**RIDGE FARM
FINAL PLAN PHASE 1C
MAJOR PLAN 2017-101**

TO: PLANNING COMMISSION
FROM: GREGG R. ADAMS, PLANNER
SUBJECT: RIDGE FARM FINAL PLAN PHASE 1C
MAJOR PLAN 2017-101
REQUEST FOR FINAL PLAN REVIEW

SUBJECT: South Whitehall Township
Ridge Farms
Major Subdivision #2017-101
Phase 1C Final Plan Review

Drawing Title: **UTILITY PLAN**

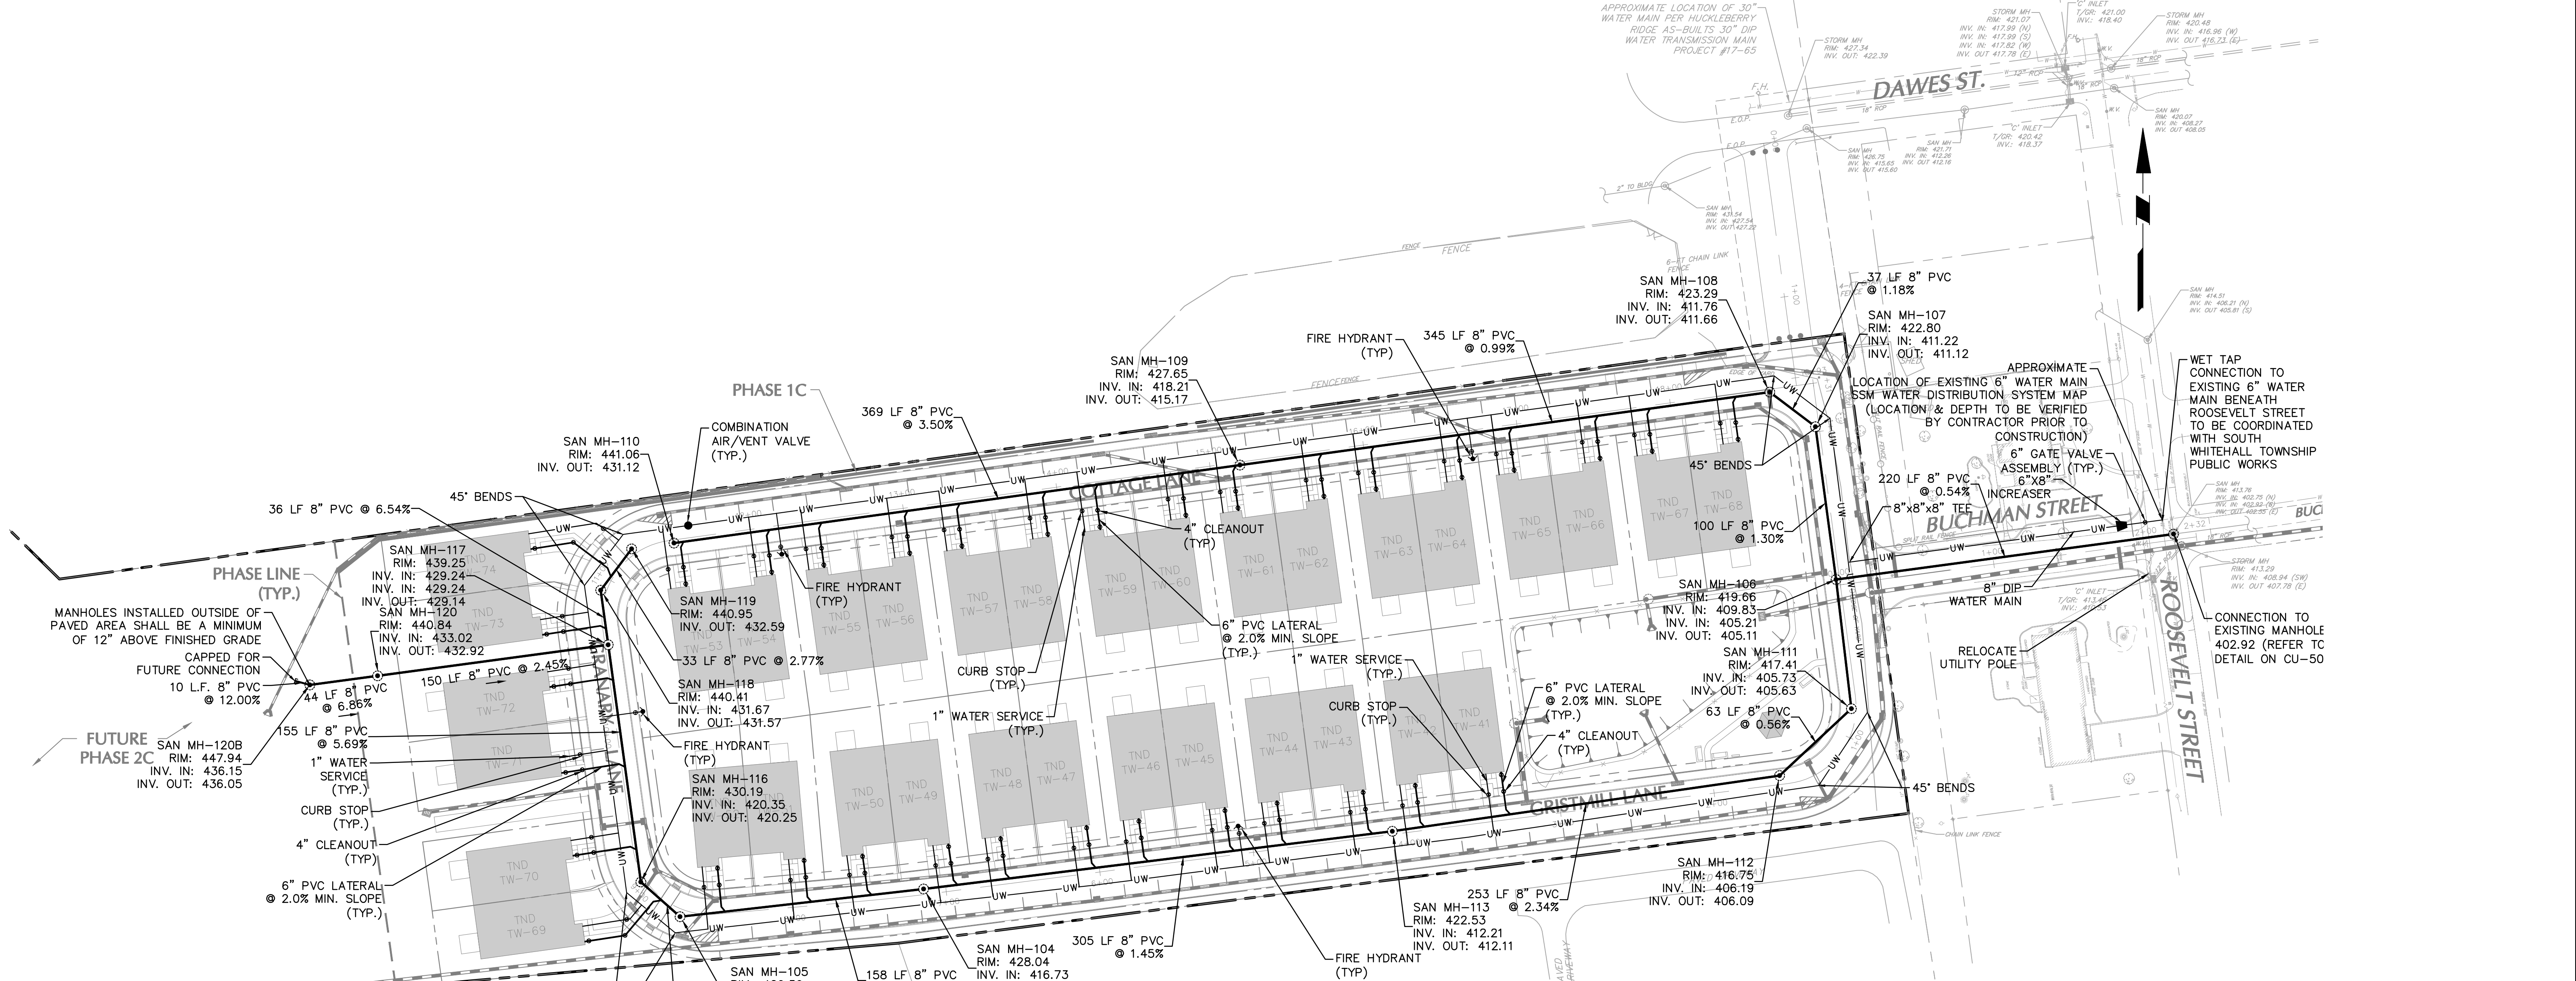
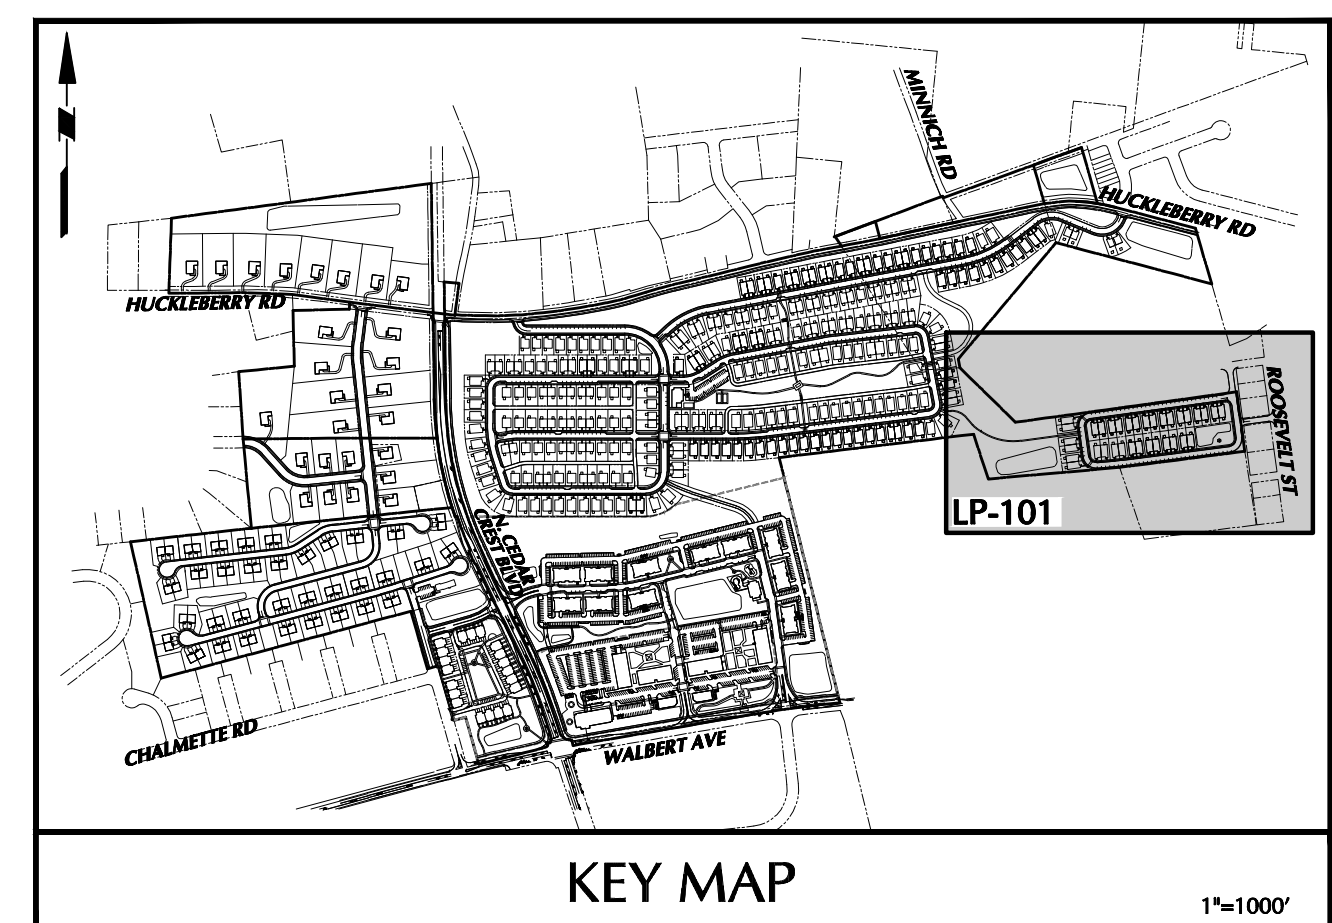
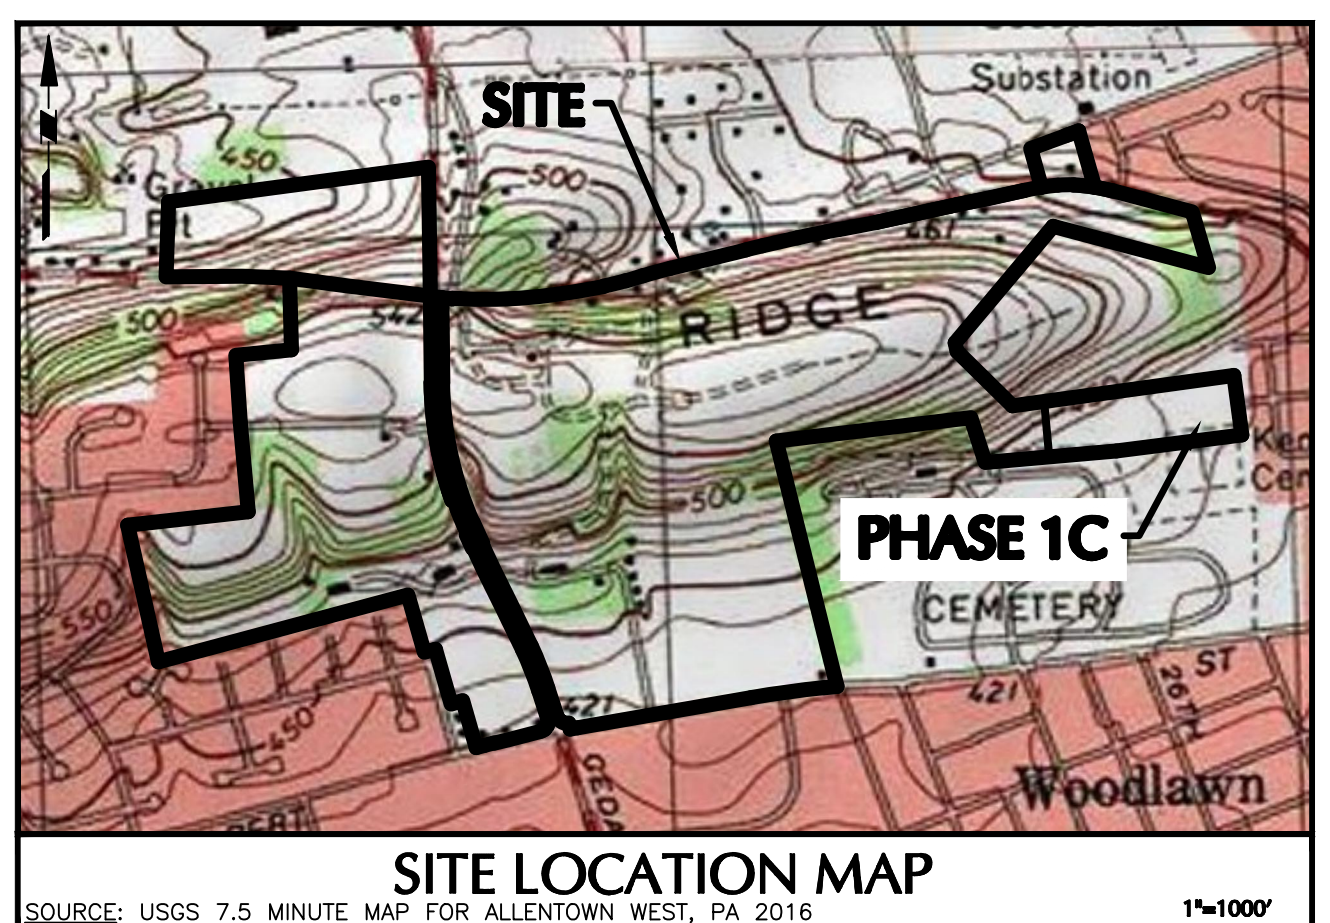
1. **Utility Plan CU-101 Sheet 19 Of 26** - Add to Utility Notes -
Where required to install the waterline deeper to avoid conflict with other utilities, deflect the waterline with the use of 45-degree bends and return to 4 feet of cover. Water valves shall be placed at depths no greater than 4 feet. [SWT Construction Standards - Laying and Construction of Pipe. Page B-27]
2. **Utility Plan CU-101 Sheet 19 Of 26** – Add to Note 13 –
No water line should be deeper than 6ft.

1. **Utility Plan CU-101 Sheet 19 Of 26** – Near station 0+00 at the 8” Water main tee located on Gristmill Lane, Cottage Lane and Buchman Street add three 8” water valves. [one valve on the north side of 8” tee Cottage Lane and one 8” valve on the south side of the 8” tee Gristmill Lane and one 8” valve on the east side of 8” tee Buchman Street.
2. **Utility Plan CU-101 Sheet 19 Of 62** - Add two water main street valves - one north and one south of the fire hydrant tee located on Granary Lane. This area is near station 10+00.
3. **Utility Plan CU-101 Sheet 19 Of 62** – Add water sample station on Granary Lane near Fire Hydrant. This area is near station 10+00.

Drawing Title: **LIGHTING PLAN**

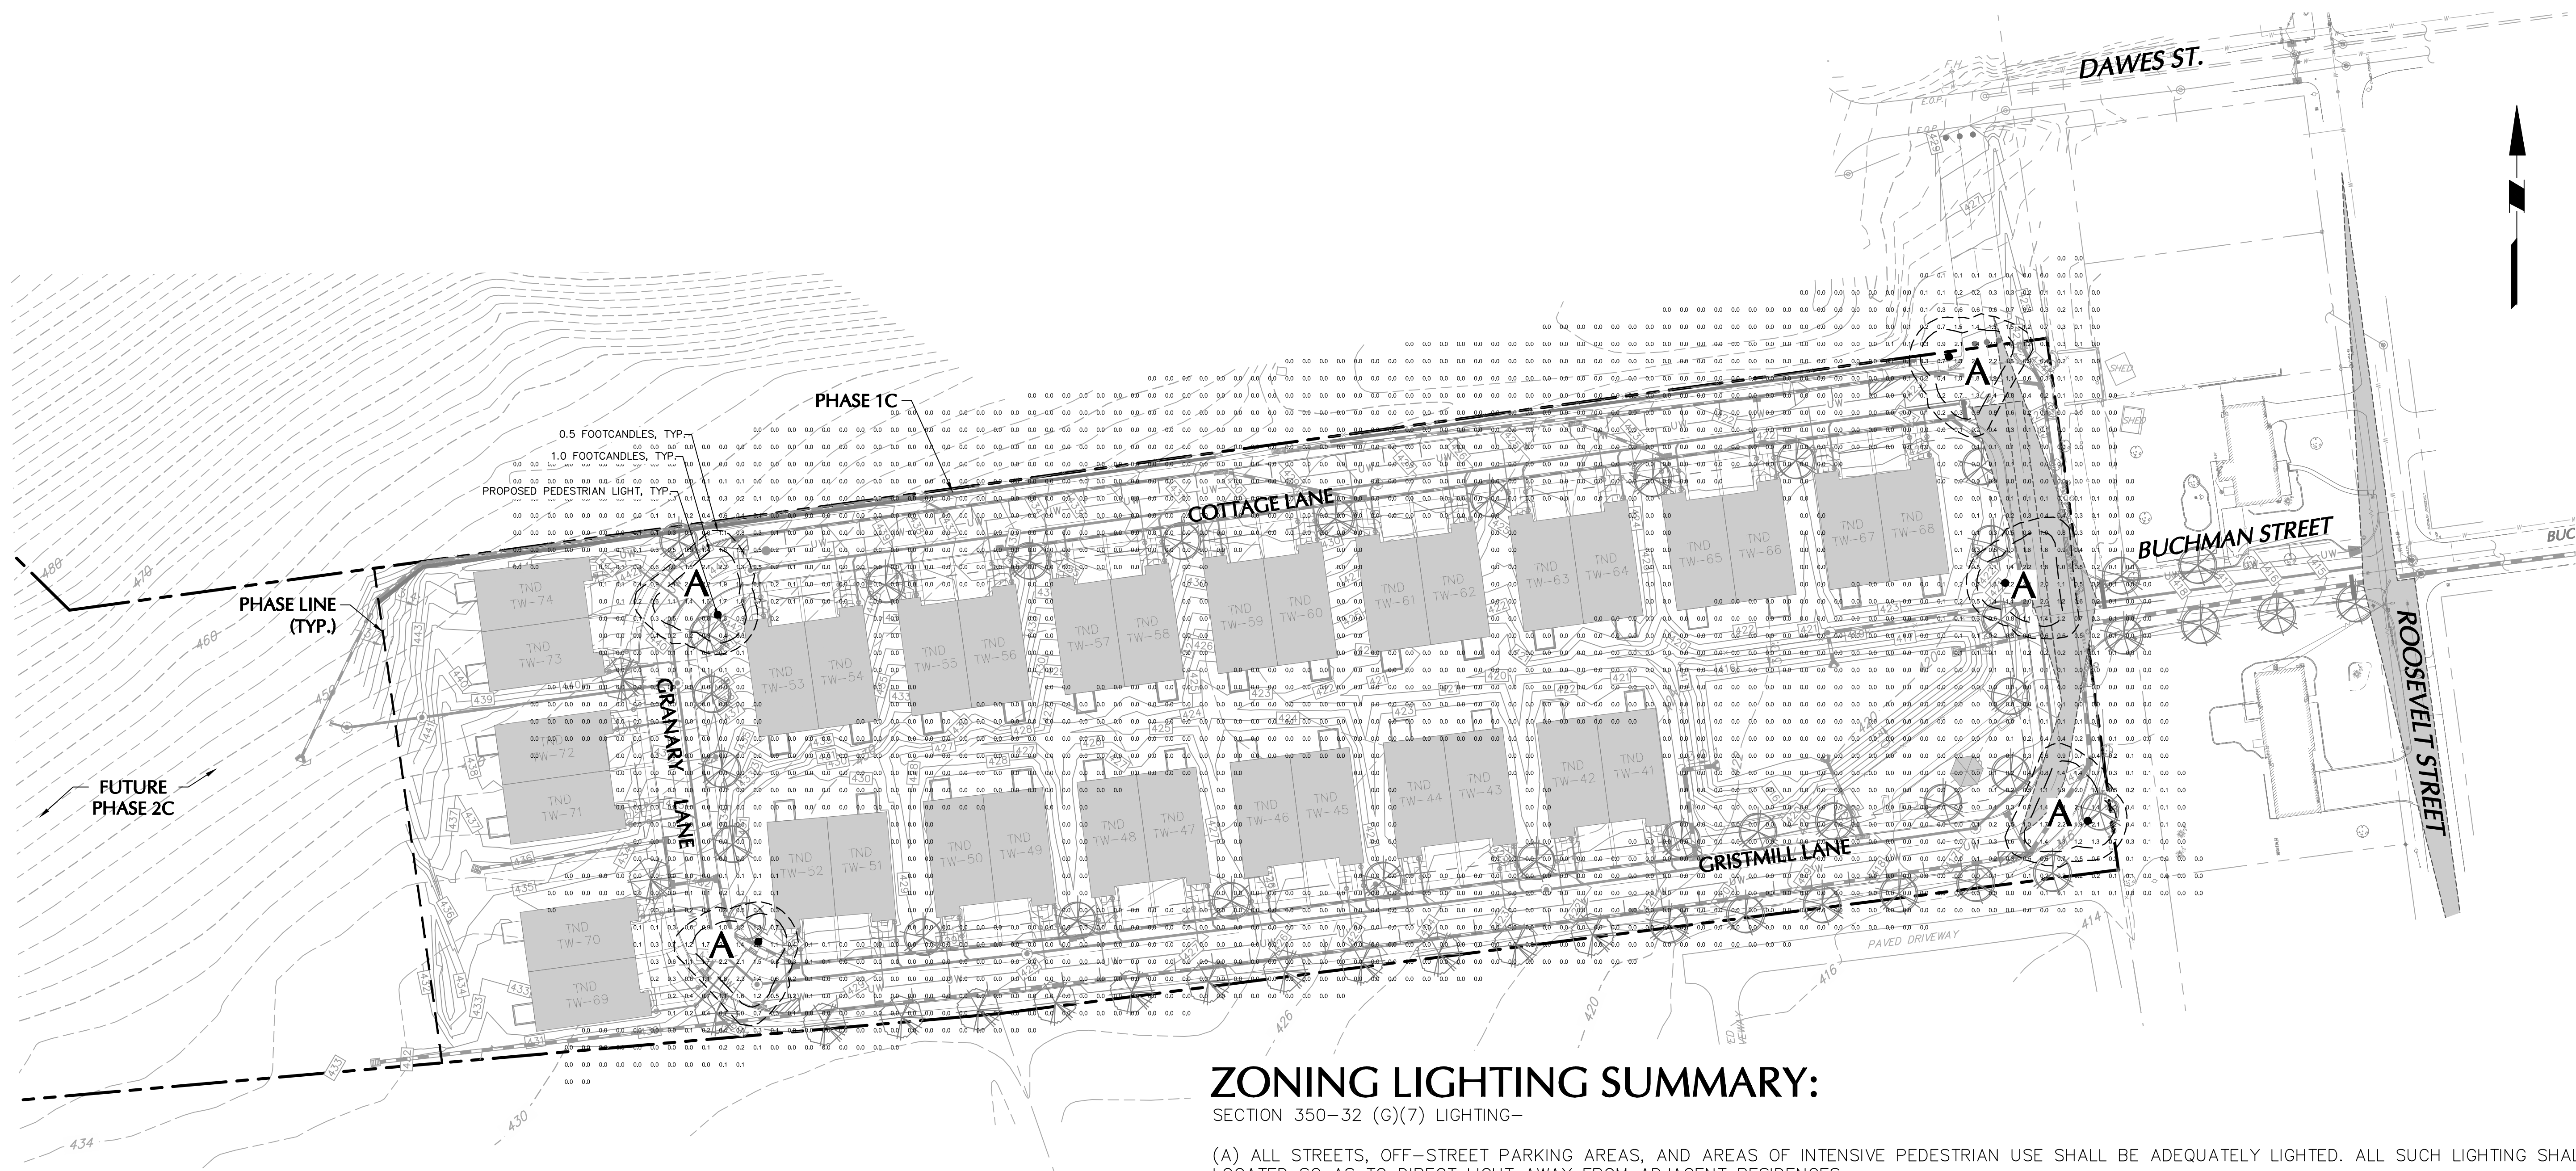
- (1) Sheet LL-101 shows zero readable light along Cottage Lane, Granary Lane, and Gristmill Lane. The township shall determine if these streets are required to comply with township ordinance 350-42.i.2 and 350-42.i.3 pertaining to illumination of private streets and driveways which requires that private streets be illuminated to IES standards.
